## Addendum No. 1

Project: Request for Proposal  
General Contractor to Construct  
Interior Modifications for  
East Meadows Family Apartments Phase I  
San Antonio, Texas

## Addendum No. 1

PROJECT NAME: East Meadows Family Apartments – Phase 1 5/3/19

#### Item No. 1 Sheet M101 – Floor Plans – Plumbing

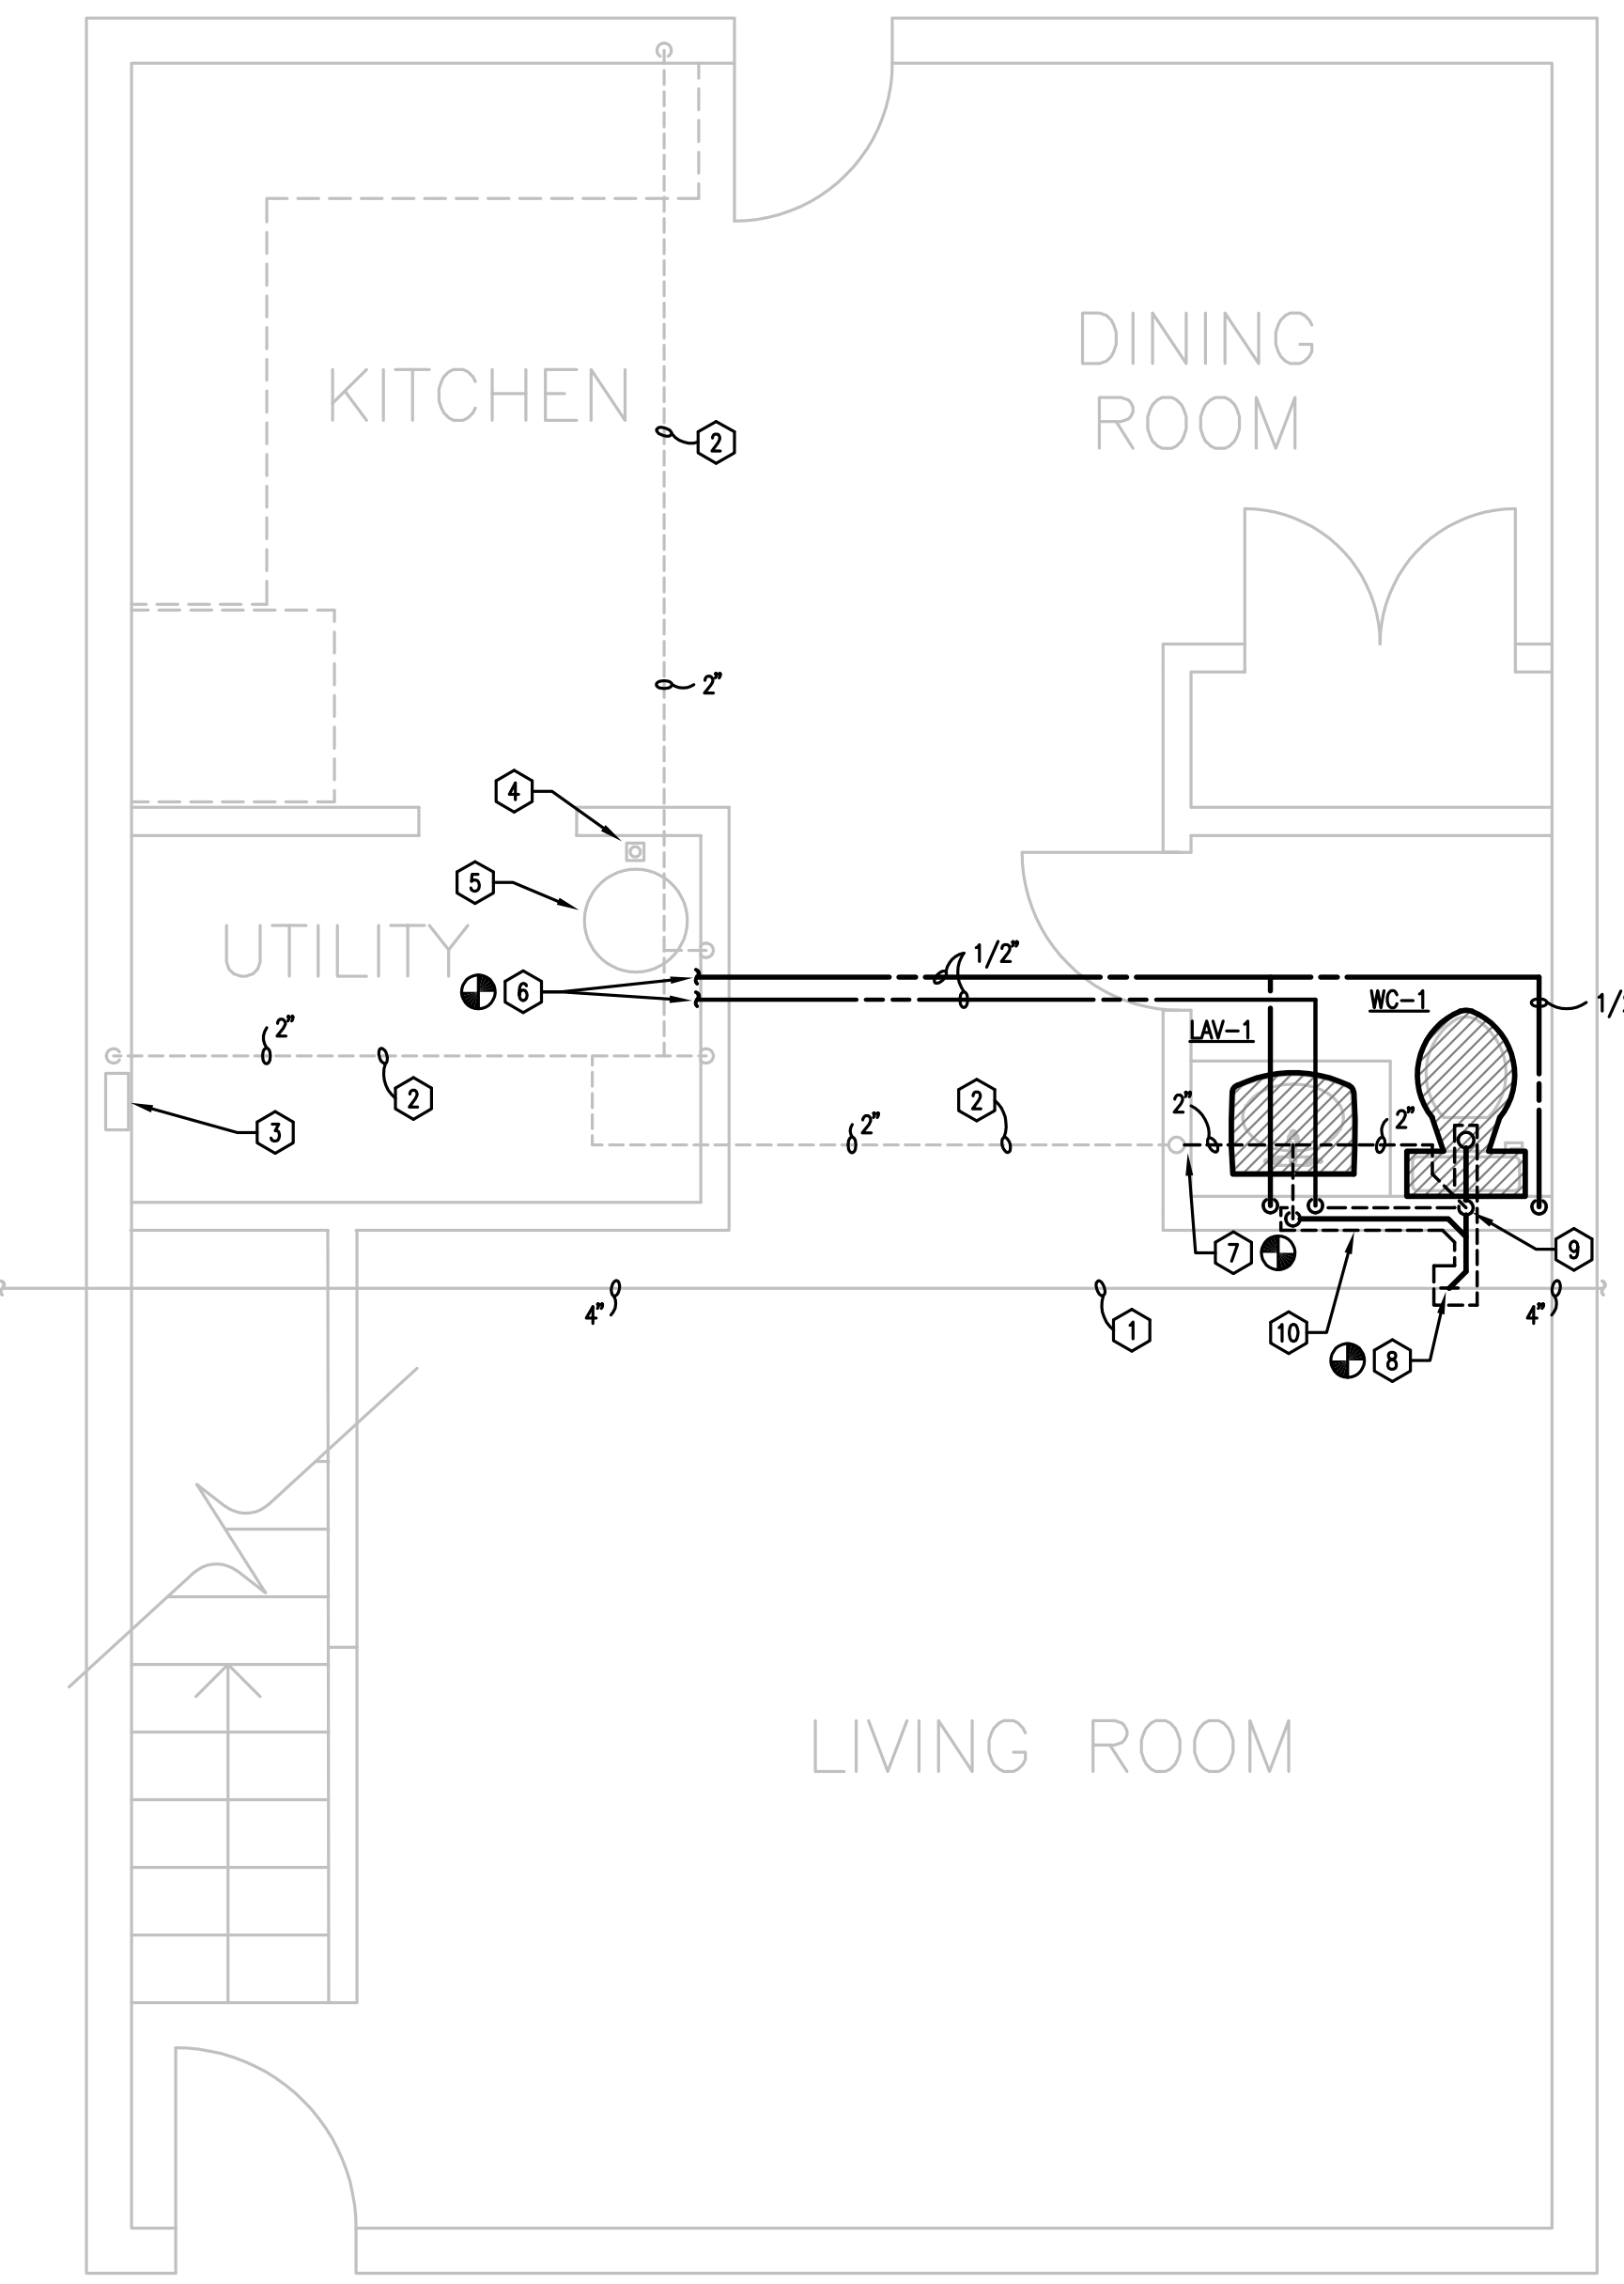
- a. In the two (2) bedroom units only, Contractor shall furnish and install a sprinkler head in the new restroom. Extend sprinkler piping from the existing system located on the hall. Installation of sprinkler system shall be in accordance with NFPA 13R. Contractor shall notify Building Management of shutdown of fire sprinkler system allowing the Contractor to make connection to the existing system. See attached full size Sheet M101.

1. SPRINKLER CONTRACTOR SHALL FURNISH & INSTALL SPRINKLER HEAD IN NEW RESTROOM OF ALL 2 BEDROOM UNITS. EXTEND PIPING FROM EXISTING. SPRINKLER SYSTEM SHALL BE IN ACCORDANCE TO NFPA13R. REFER TO SHEETS SP101, SP102, SP103 & SP104 FOR LOCATIONS AND QUANTITY OF 2 BEDROOM UNITS.
2. CONTRACTOR SHALL NOTIFY BUILDING MANAGEMENT FOR SHUT DOWN OF SPRINKLER SYSTEM ALLOWING CONNECTIONS & EXTENDING THE FIRE SPRINKLER SYSTEM FROM EXISTING.
